Re: Chicopee Levee Slope Stability – Response to USACE Comments
Uniroyal Filling Project
Chicopee, Massachusetts

Updated Geotechnical Analyses
Slope Stability
Uniroyal Site Filling Project
Chicopee, Massachusetts

REVIEW COMMENTS

Project Name: Former Uniroyal-Facemate Property Filling Project	Date: 23 September 2020
Location: Chicopee, MA	Reviewers: Kevin DiRocco/ Patrick Blumeris
USACE ICW Project: Chicopee Riv LB - Chicopee Falls, MA	
Documents Reviewed: (1) Stormwater Management Report, Former Uniroyal & Facemate Properties, Chicopee, MA, dated July 2020 (Marked ACOE Permit Only) (2) Figure No. 3 through No. 11, dated July 24, 2020 titled: Former Uniroyal & Facemate Properties (Marked ACOE Permit Only) (3) Letter report prepared by O'Reilly, Talbot & Okun Associates for BETA Group, titled Chicopee Levee Slope Stability, Uniroyal Filling Project, dated Sept. 14, 2016. (4) Letter report prepared by O'Reilly, Talbot & Okun Associates for BETA Group, titled Chicopee Levee Slope Stability, Uniroyal Filling Project, dated Sept. 29, 2017	
Submitted By: BETA Group	Submittal Dated: Varies

CASE 5
Station 41+00 - Normal Water Conditions

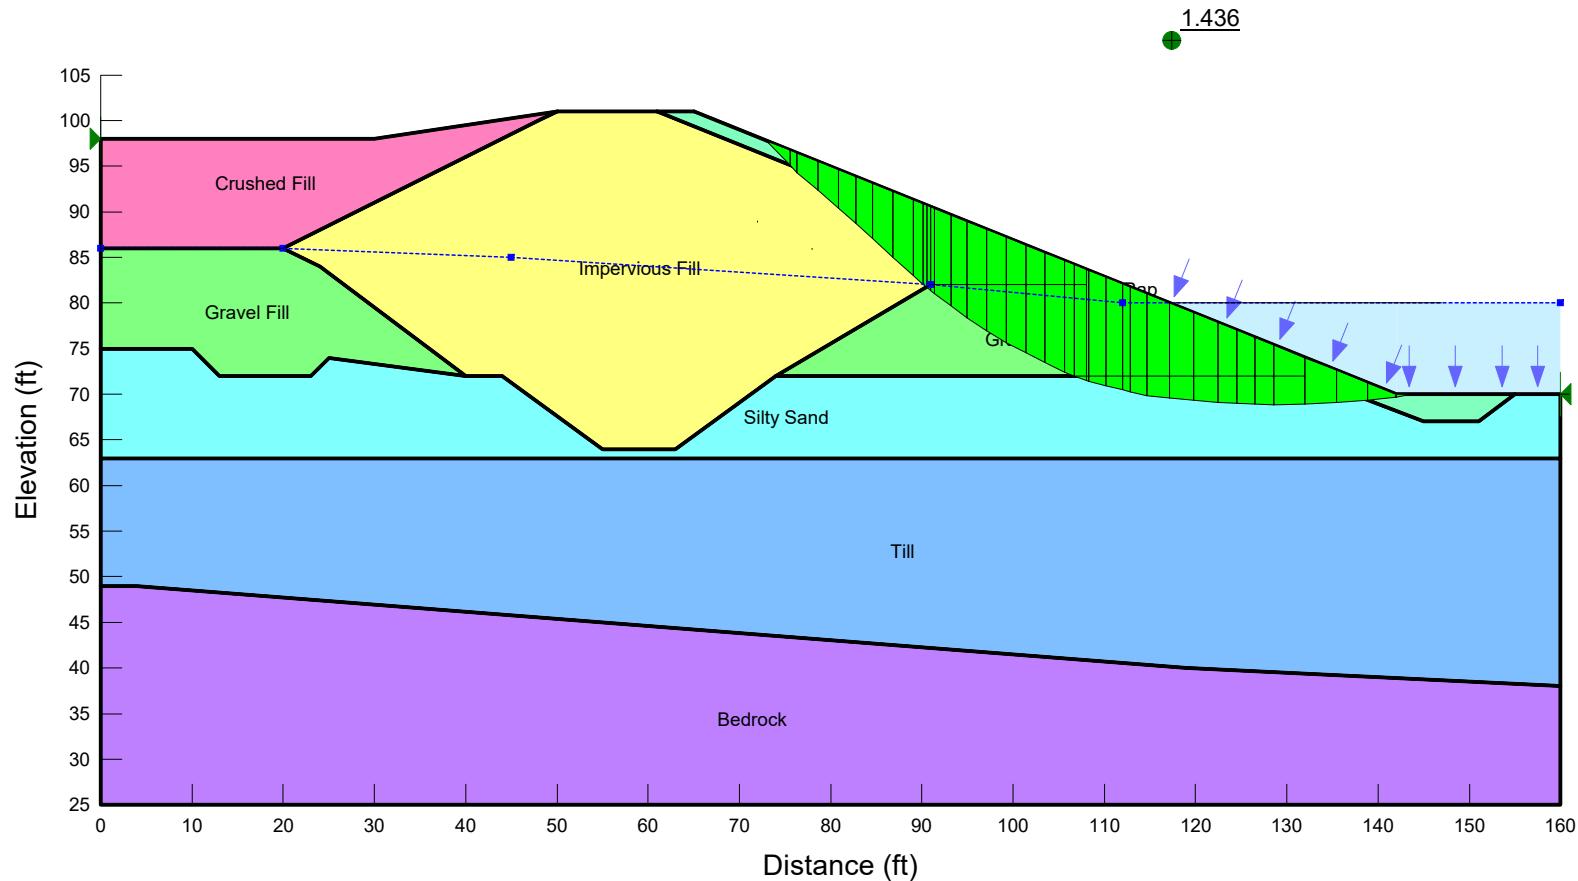
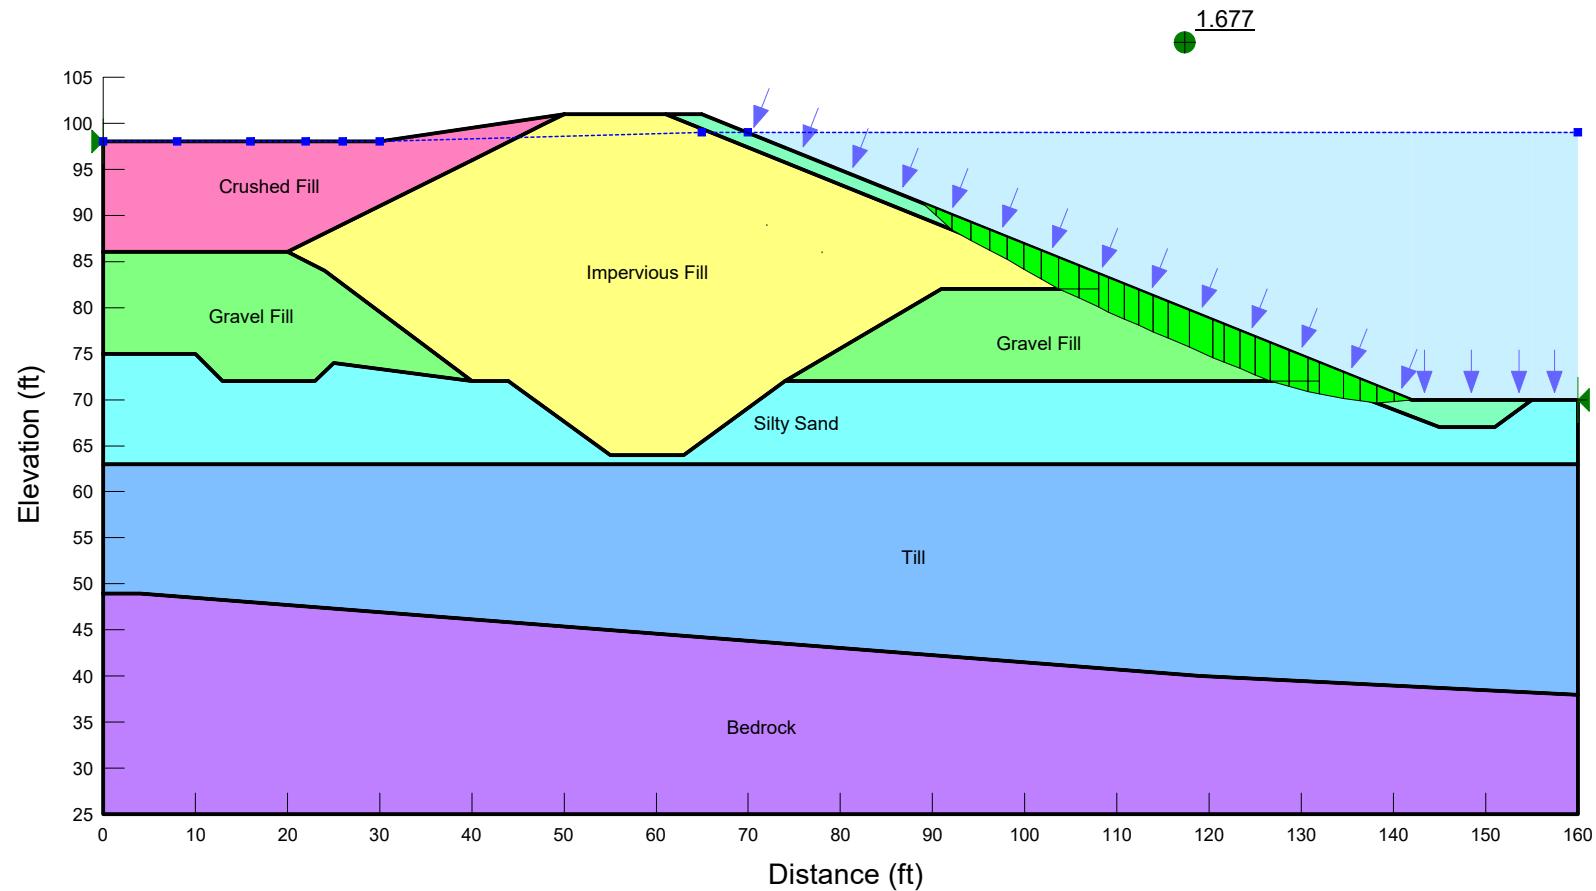
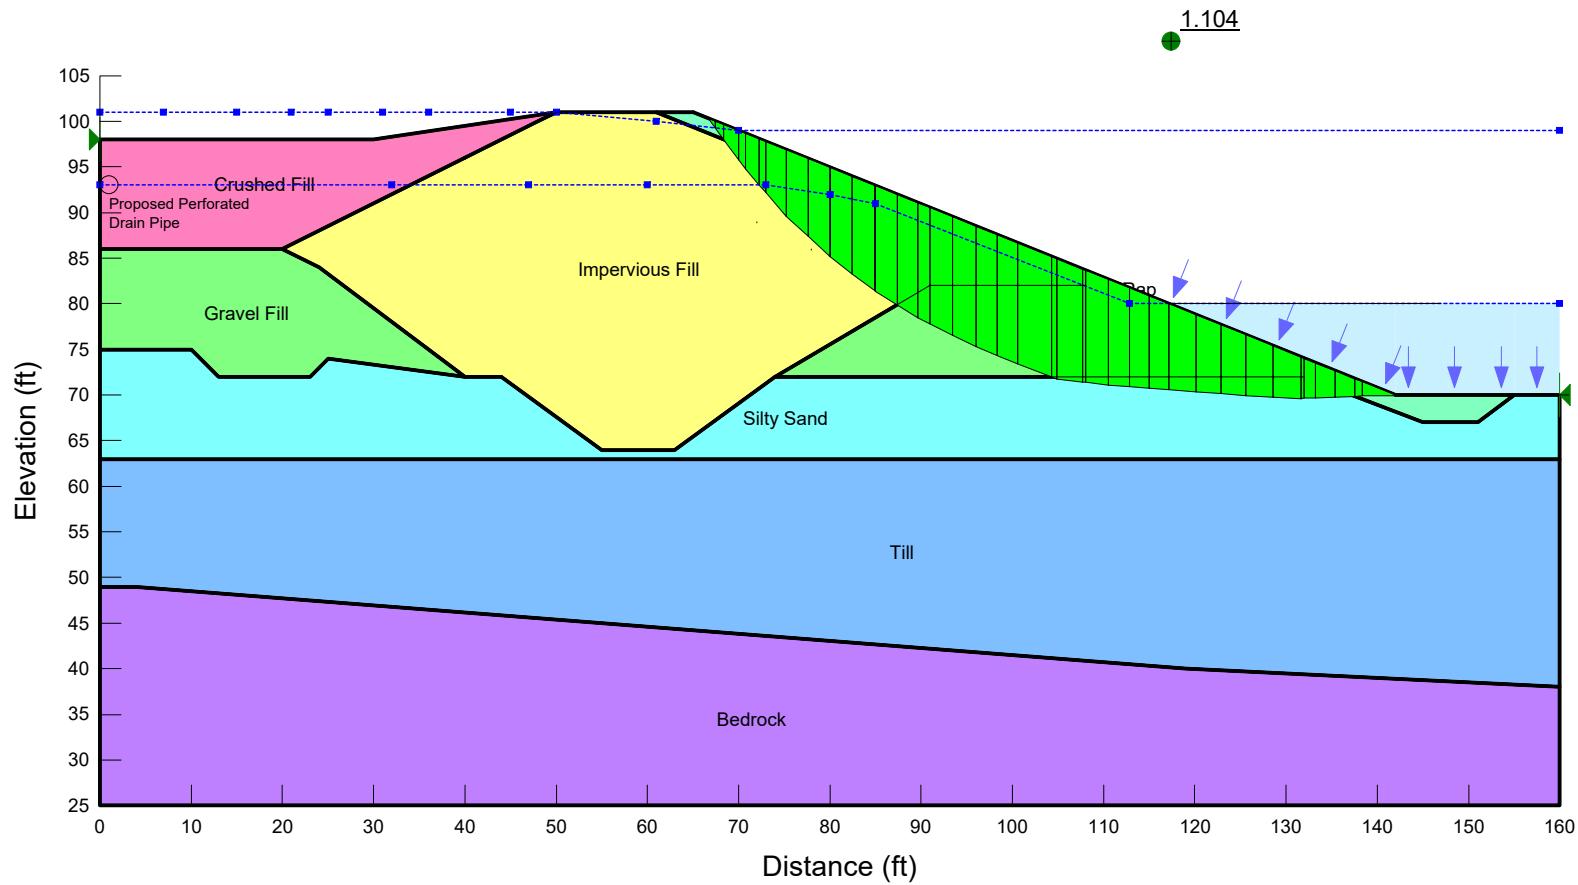
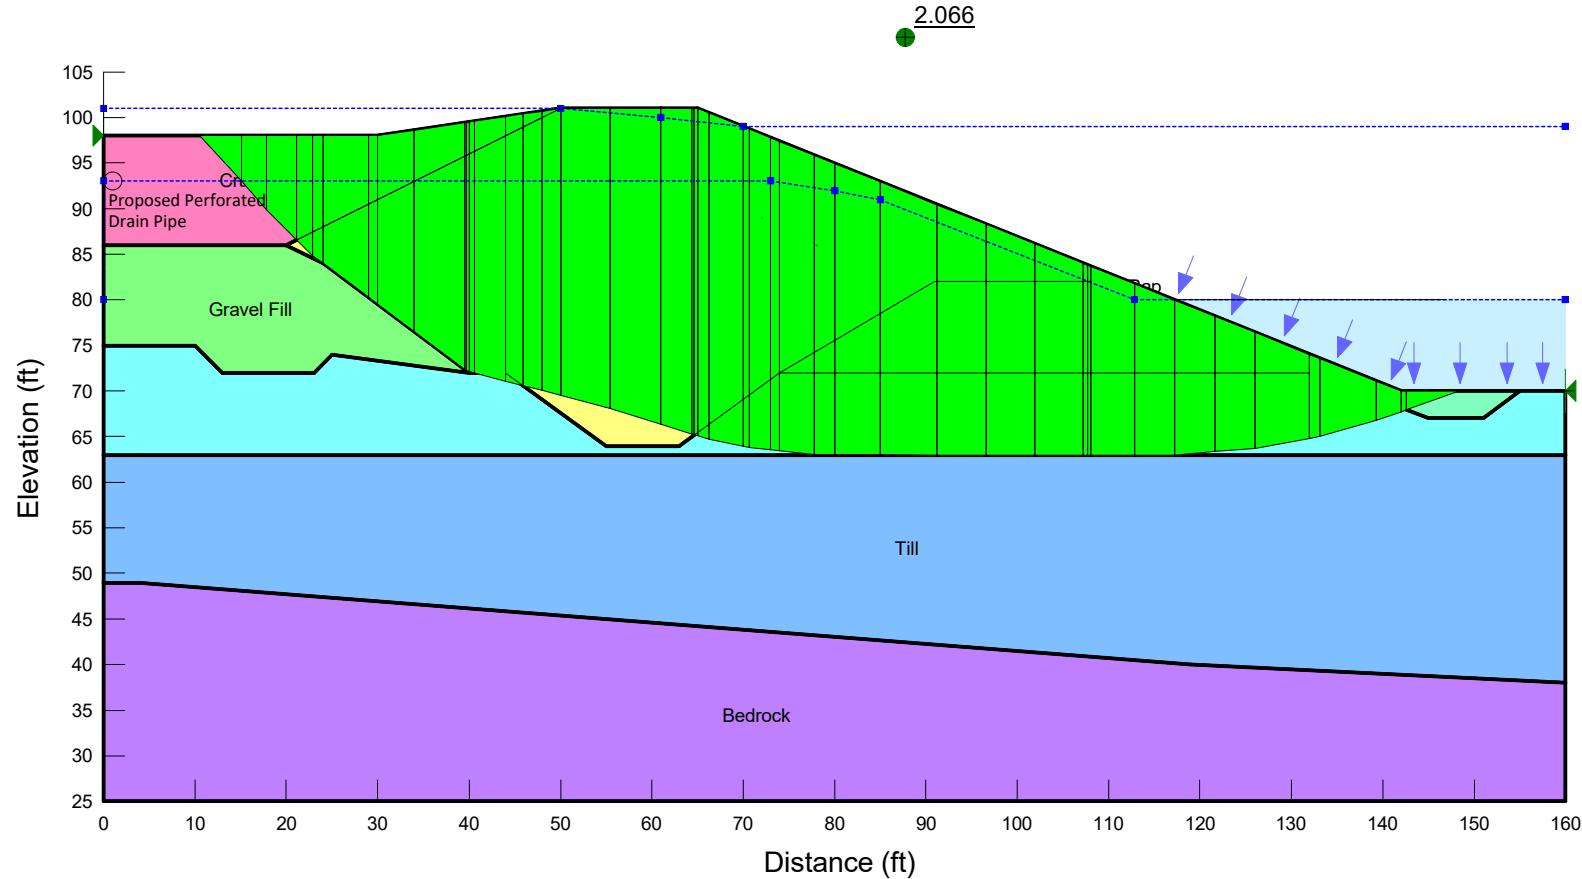
No.	Reference	COMMENTS	RESPONSE
18.	Doc. Nos. 3&4	<p>The stability analyses show the landside groundwater during rapid drawdown will be at or close to the normal level in the granular fill shown beneath and landward of the levee embankment. Seepage analyses are not provided, and it is not clear if the analysis for determining the landside groundwater level included the benefit of the toe drain or assumed that the granular fill provided drainage. It seems likely that the analysis considered the toe drains given the reliance on the BEC analyses and recommendation to provide a landside blanket drain connected to the toe drain. The current fill plan calls for abandonment of the toe drain, so the analysis needs to assume that the toe drain does not exist. Also, it is not clear if the analyses considered the following:</p> <ul style="list-style-type: none">○ The current plan for the site filling, does not include the blanket drain on the landside slope of the embankment recommended in the original stability report.○ The gradation of the "crushed fill" placed landward of the levee embankment is likely to be highly variable and the permeability is unknown. This fill is unlikely to be free draining may retain water during a rapid drawdown scenario in the river.○ The gravel fill shown in the Sta. 41+00 cross section may not extend the full width of the fill area landward of the existing levee embankment and the former building walls likely penetrate the gravel fill, forming a seepage block. Also, according to DM-2, the levee embankment downstream of Sta. 35+00 was constructed within the former river channel, and as a result, the gravel fill in this area may have been placed within the original river channel to increase the size of the Uniroyal property. As a result, the lateral extent of the gravel fill landward of the levee may be limited. The crushed fill could have a significantly lower permeability than the gravel fill, forming a low permeability cap, and increasing the steady-state seepage pressures in the gravel fill.

The water levels for the analysis at Station 41+00 have been revised assuming the gravel fill layer is saturated. The revised analysis outputs are included with this letter.
